Subject: Clinton Power Station Unit 1
Humphrey Concerns

Reference: IP letter U-0596 dated 2/4/83, G. E. Wuller to
A. Schwencer, NRC, subject: Submittal addressing
some John Humphrey concerns.

The referenced letter addressed some of the John Humphrey concerns as applicable to the Clinton Power Station (CPS). Enclosed are CPS responses on some additional Humphrey issues for NRC Staff review. Included are Action Plans #15, 18, 19, 22, 25, 28, 31 and 32. We believe that these responses will resolve the particular concern involved.

FIG 284 - CASE 4: ISOLATION SCRAM - SORV ON ISOLATION

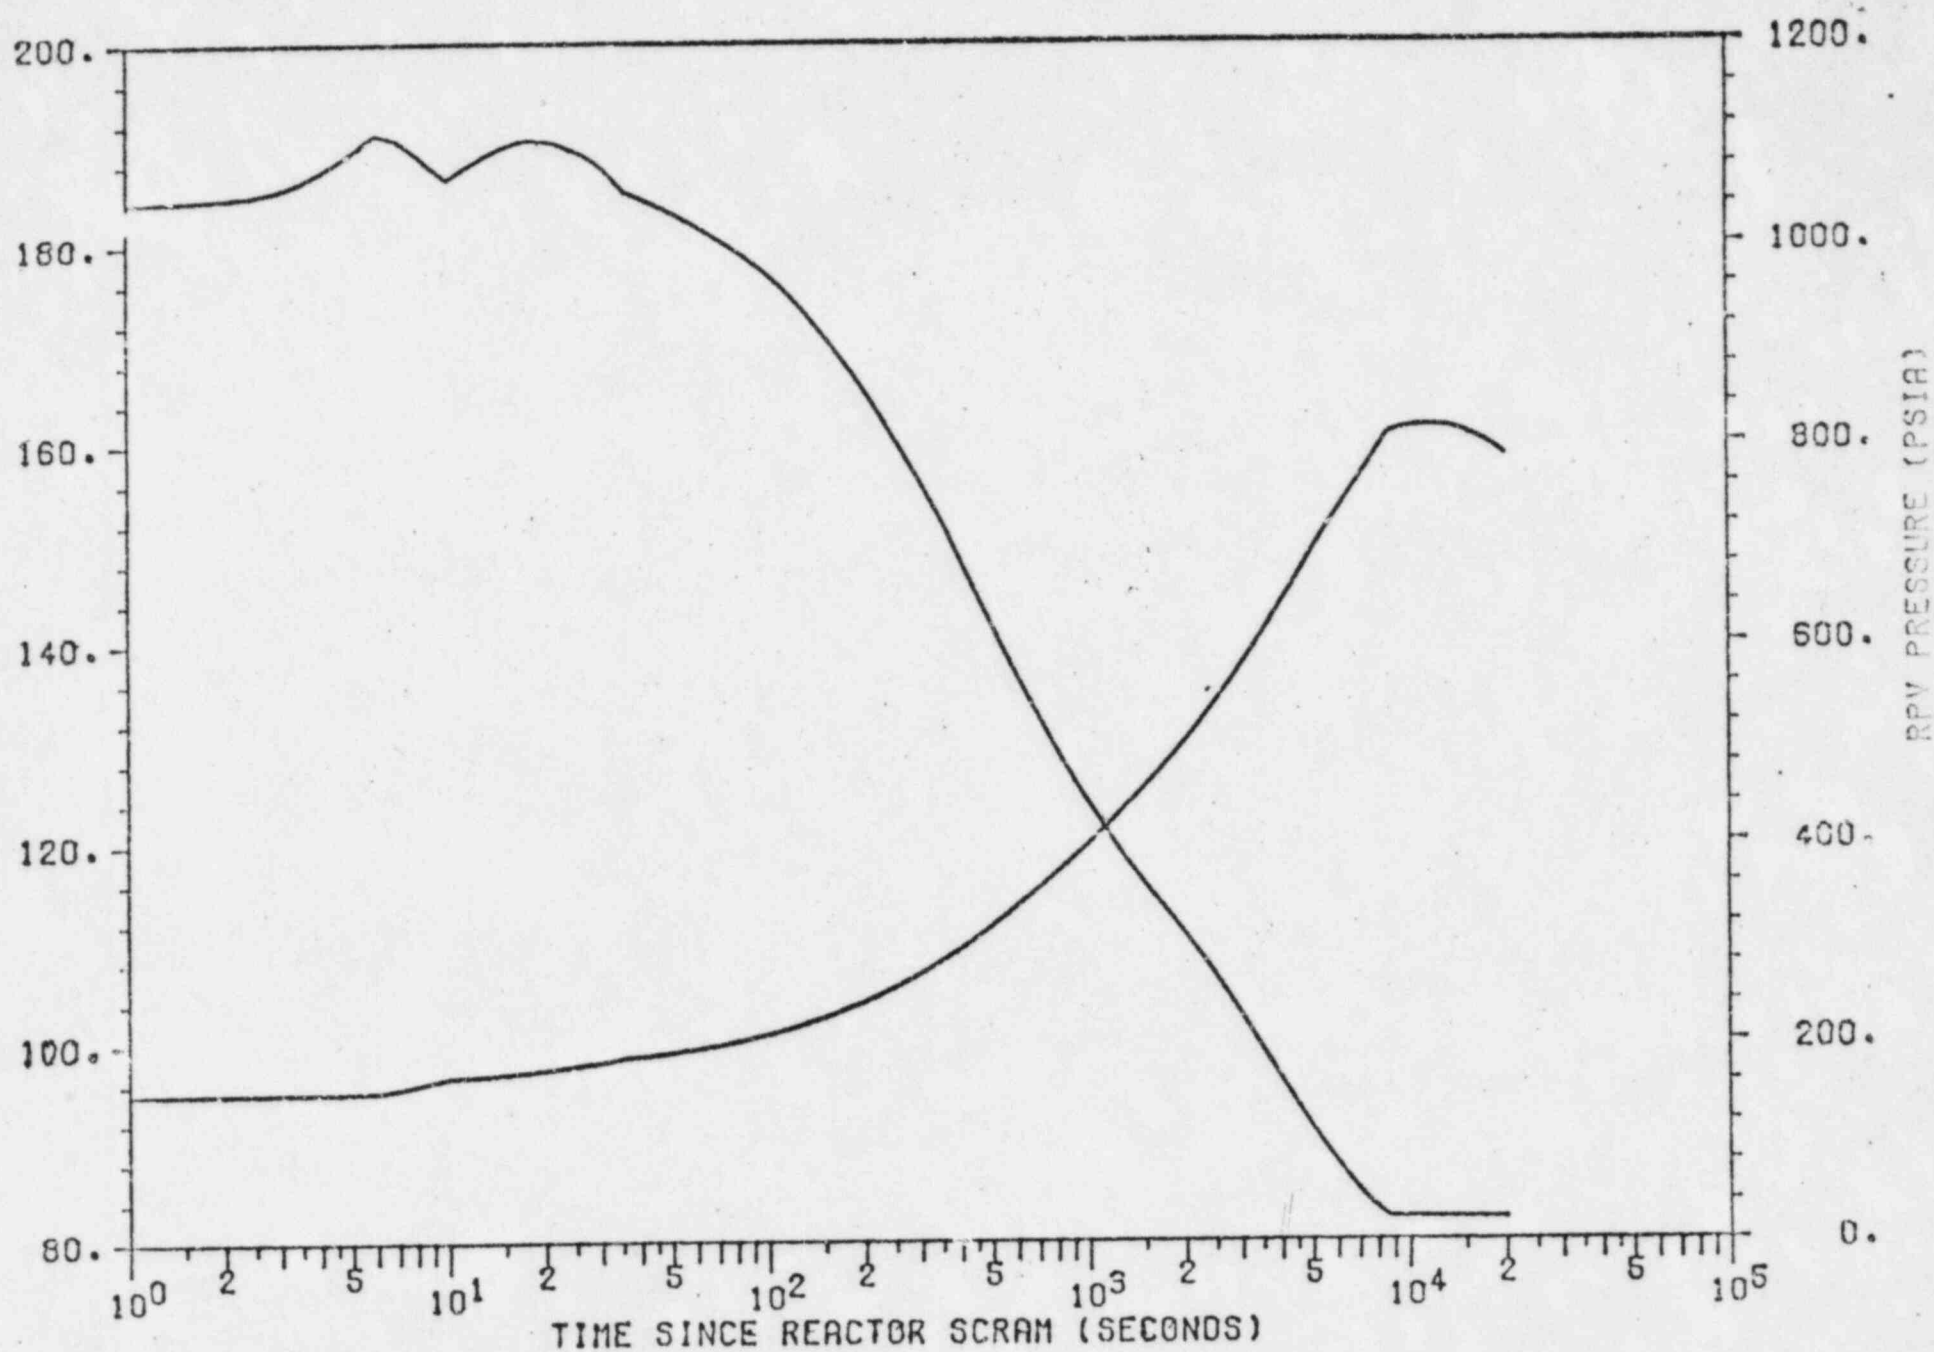
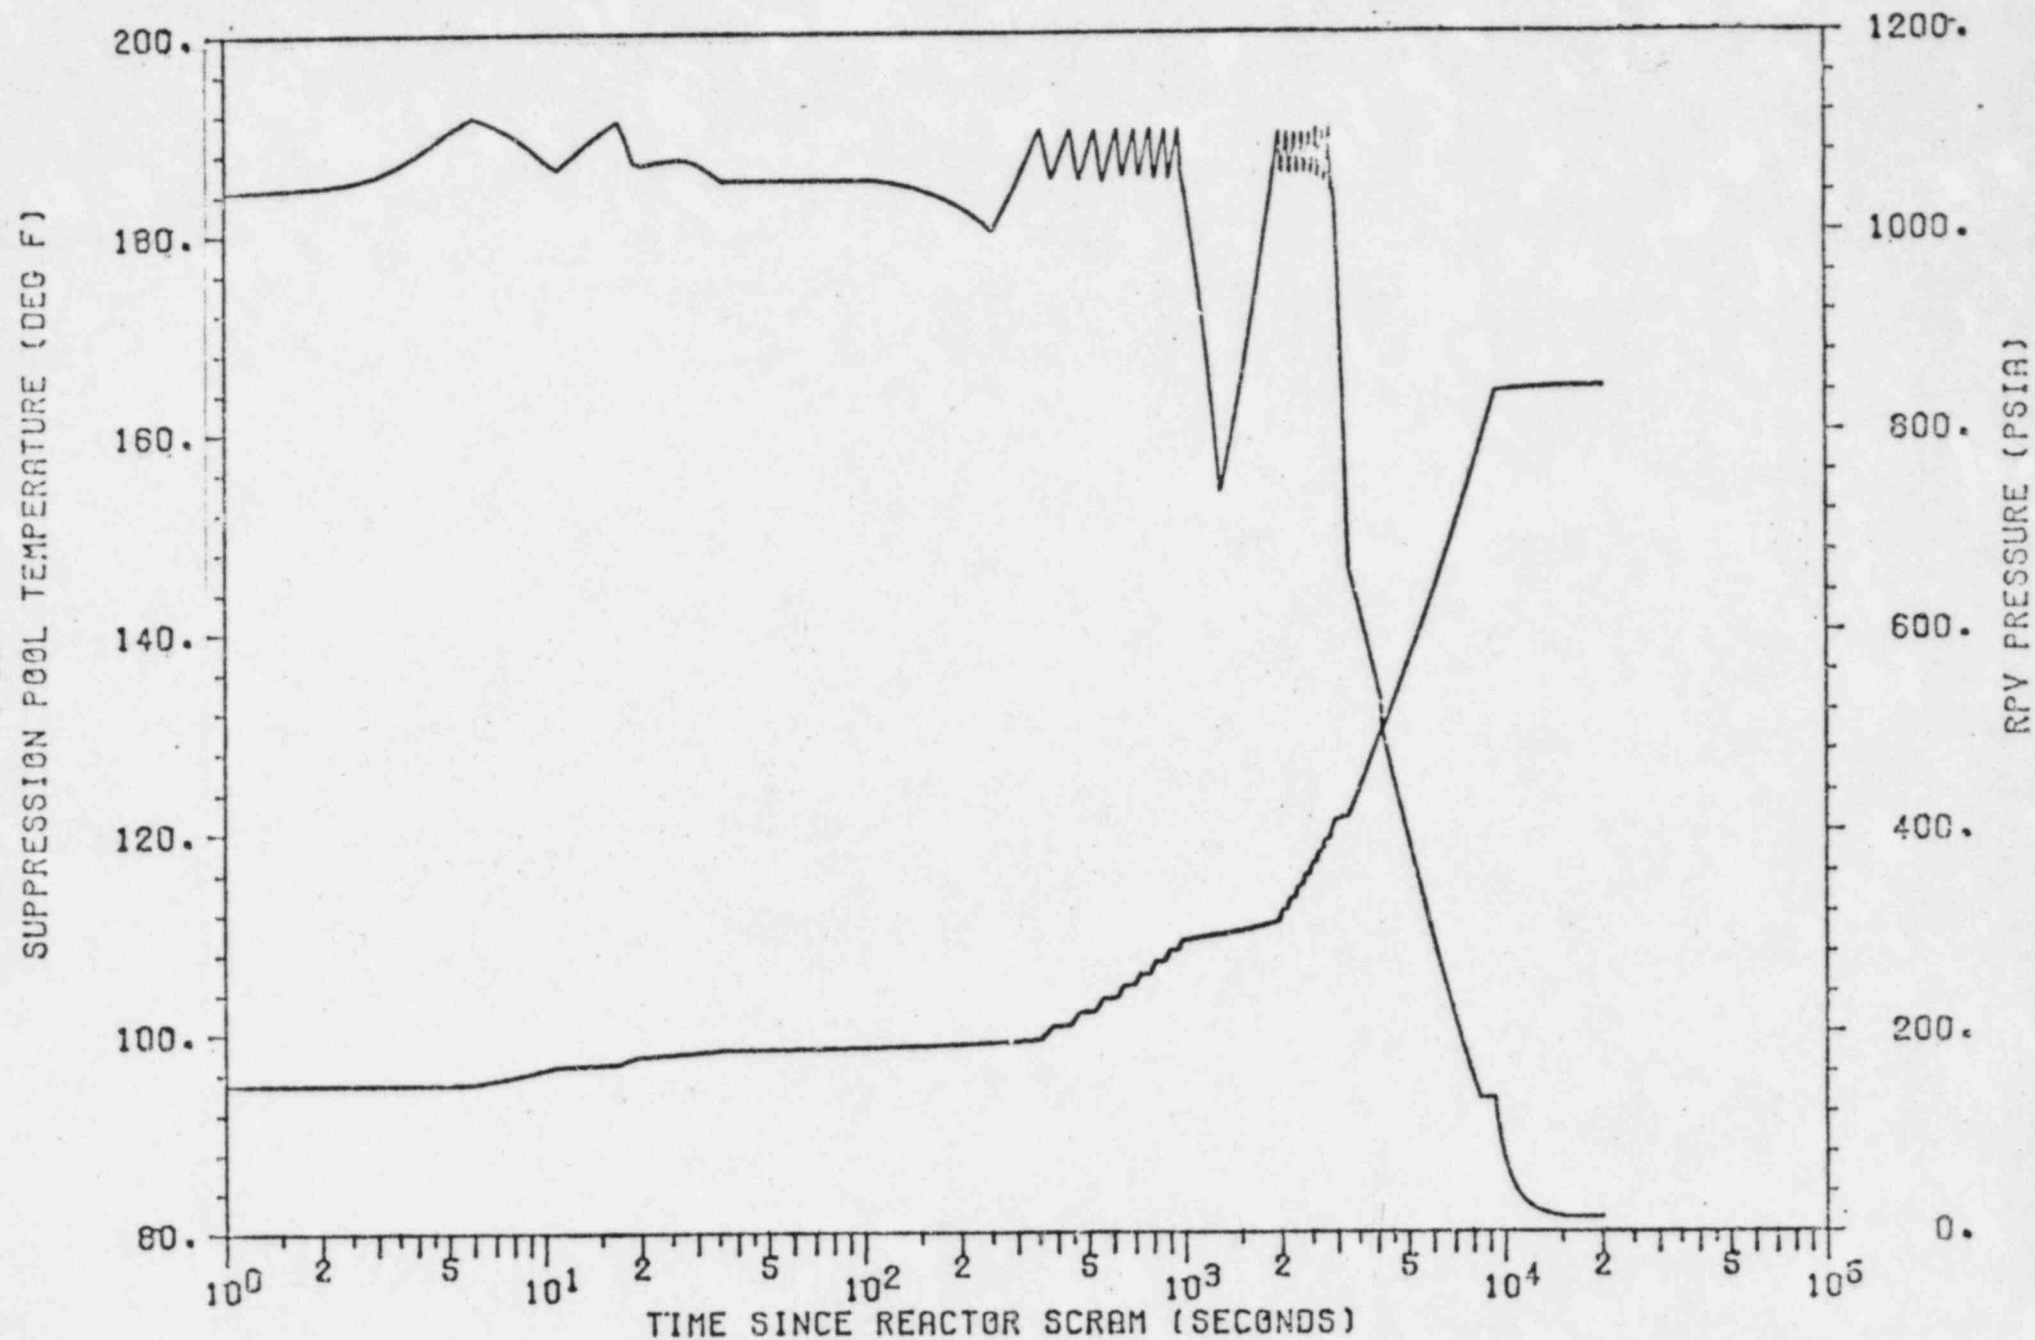
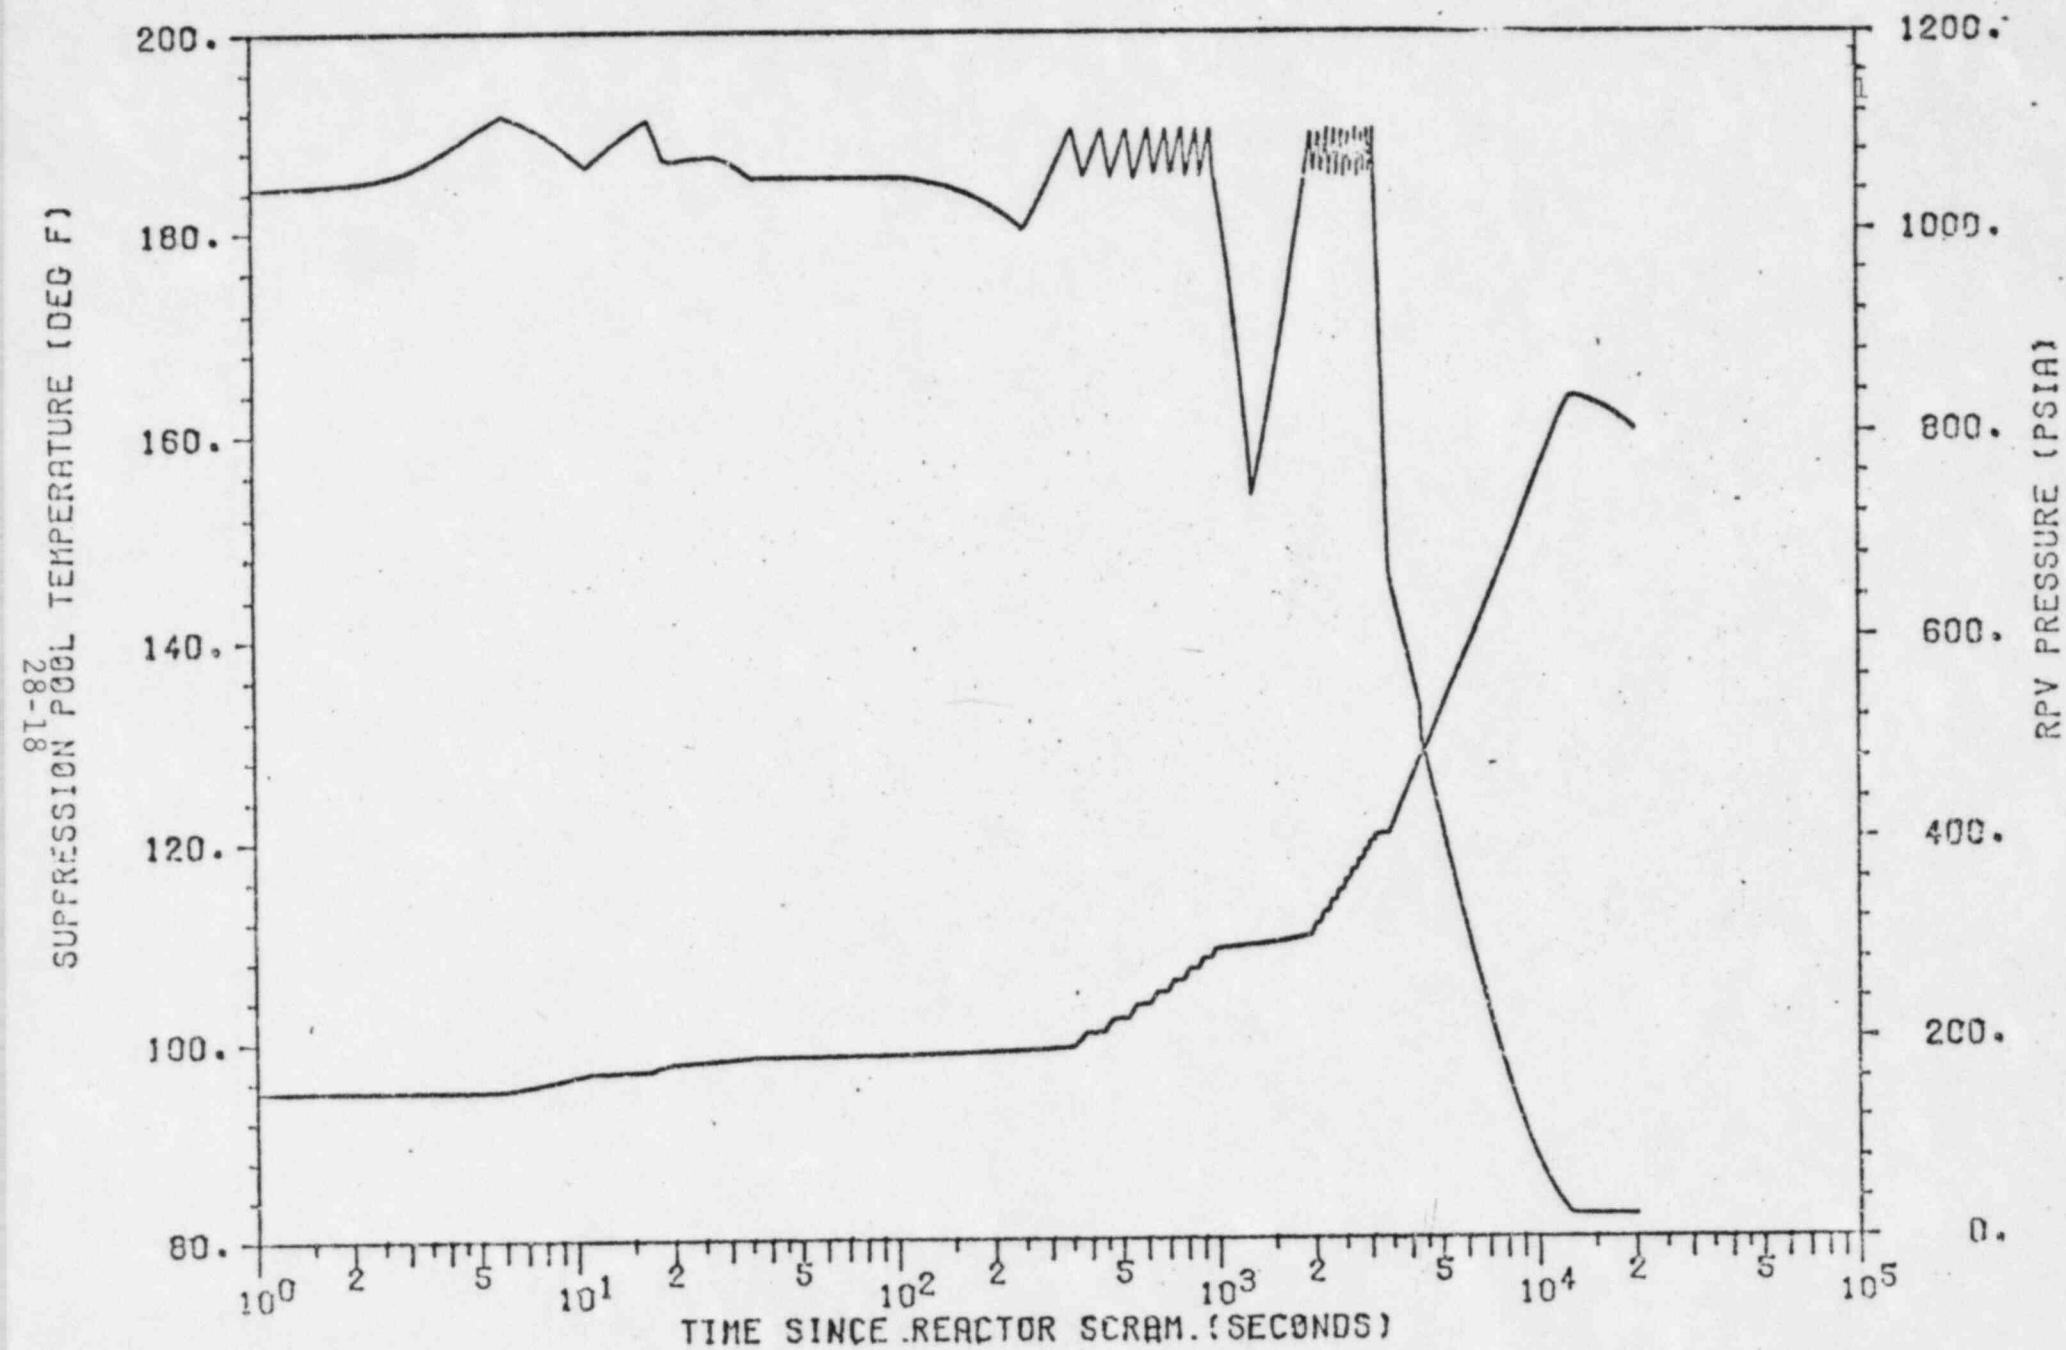
- 9.3 It appears that some confusion exists as to whether SBA's and stuck open SRV accidents are treated as transients or design basis accidents. Clarify how they are treated and indicate whether the initial conditions were set at nominal or licensing values.
- 9.4 The design basis calculations for stuck open relief valves should not rely on a manually initiated scram to occur within a short time interval of the SRV occurrence. The analysis should assume that scram is initiated when the pool temperature reaches 110°F or 10 minutes after occurrence of the SORV.

The stuck open relief valve transients and small break accident transients in the suppression pool have been evaluated (see attachment I). The results of this evaluation shows that the maximum suppression pool temperature expected is 171°F. This is less than the design temperature of 185°F.

The six identified transients are: (1) Stuck open relief valve (SORV) at full power with a loss of 1 residual heat removal (RHR) heat exchanger and with the condenser available to an RPV pressure of 150 psia; (2) SORV at full power with spurious isolation; (3) Isolation scram with 1 RHR heat exchanger available; (4) Isolation scram with SORV and loss of shutdown cooling; (5) Small break accident (SBA) with a loss of 1 RHR heat exchanger; and, (6) Small break accident (SBA) with loss of shutdown cooling. A detailed description of assumptions relevant to each of the cases is presented in Table 28.1 and 28.2. Table 28.3 presents the Clinton specific data that were used in these evaluations. Pertinent parameters related to the SRV's are presented in Table 28.4. The assumed system delay times are summarized in Table 28.5. The event sequence for each analysis is given in Table 28.6. Final results are shown in Table 28.7.

Figure 32-1 CPS Containment Spray and LPCI Piping Schematic

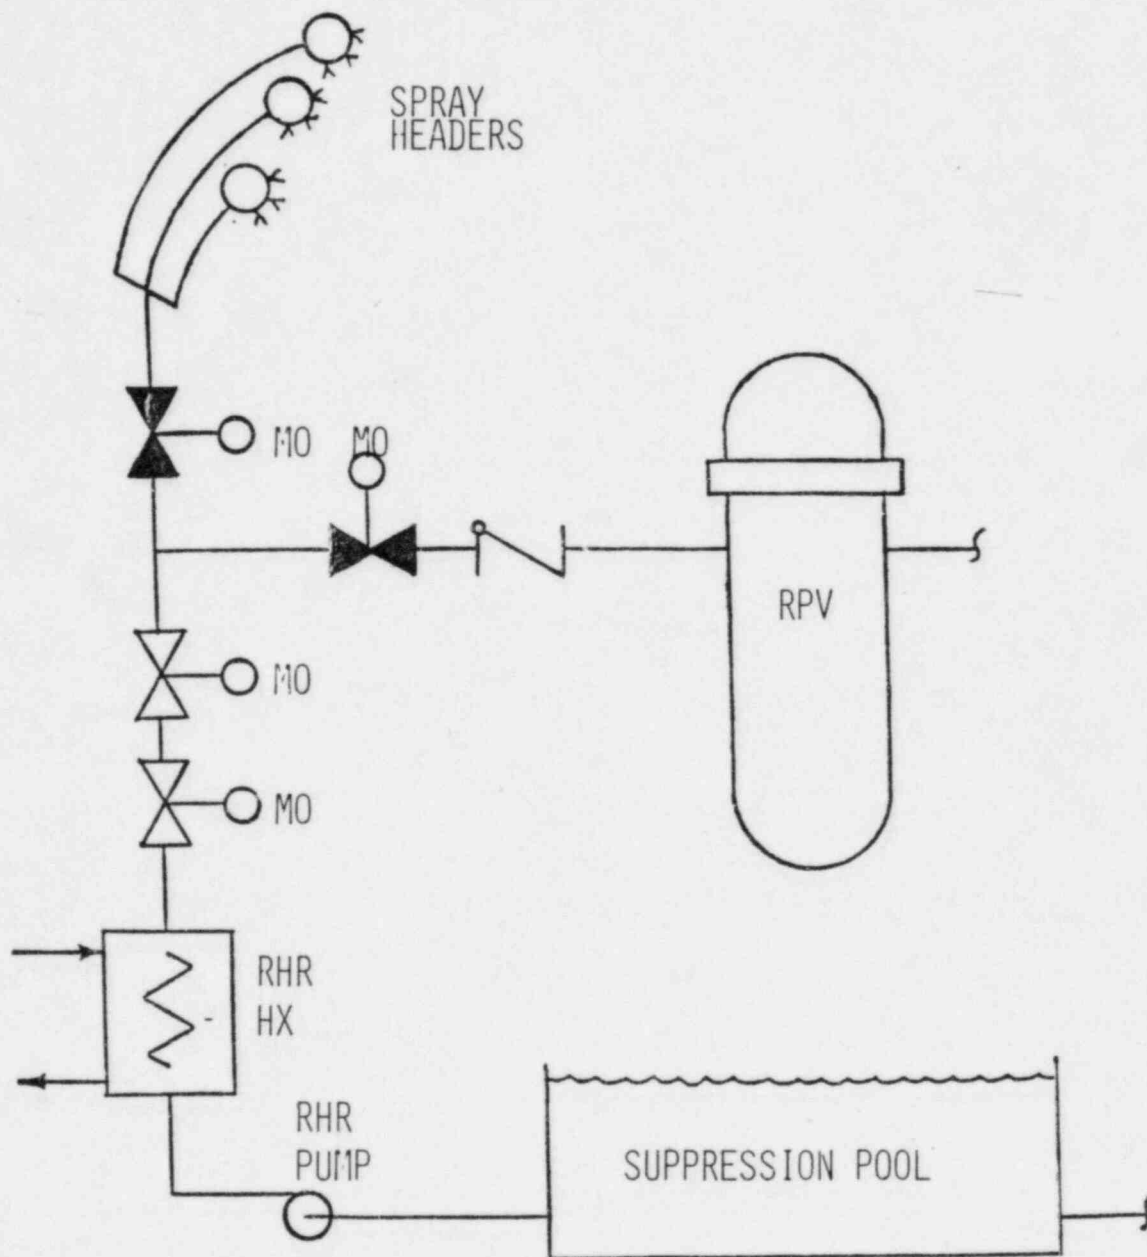
- 14.0 A failure in the check valve in the LPCI line to the reactor vessel could result in direct leakage from the pressure vessel to the containment atmosphere. This leakage might occur as the LPCI motor operated isolation valve is closing and the motor operated isolation valve in the containment spray line is opening. This could produce unanticipated increases in the containment pressure.

In response to 32.1, a schematic diagram depicting the arrangement of the LPCI system and the containment spray system is included as Figure 32-1. The diagram shows only one LPCI - spray system since the analysis considers only the single active component failure on one LPCI check valve following the postulated LOCA.

Results of this analysis are summarized in Table 32.2. The leakage from the reactor through the containment spray headers pressurized the containment 0.8 psi. Thus, this postulated reactor backflow pressure analysis is very conservative for CPS and does not represent a safety concern.
